Access Compliance Report

Public Rights-of-Way

(Pedestrian Signals)

Intersection ID: N/A	Main Street:	Cross Street: N/A	Location: N/A
ADA ID: 4A6B3E08D69D	Signal Type: Two Push Buttons-Non APS	Overall Compliance: No	Severity Score: BTN 1:N/A BTN 2: N/A No BTN: N/A
Codes/Mitigation Info/Possible Solution		Field Measurements/Component Compliance

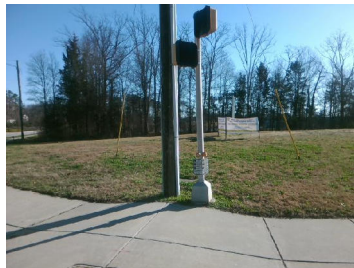
PROW/ADA: TMUTCD 4e.08, R404.2, R404.7.2, R404.3

Yes	B 1 Clear Xing Direction?	ClearlyMarked	Yes	B 2 Clear Xing Direction?	ClearlyMarked
	B 1 Crossing Direction	To NW		B 2 Crossing Direction	To SW
Yes	B 1 DistanceTo XWalk (in)	0.0	Yes	B 2 DistanceTo XWalk (in)	0.0
No	B 1 DistanceTo Curb (in)	128.0	No	B 2 DistanceTo Curb (in)	128.0
Yes	B 1 Diameter (in)	2.0	Yes	B 2 Diameter (in)	2.0

Possible Solutions: Replace Signal Push Button With APS Button on New Post. Remove & Relocate Sign.
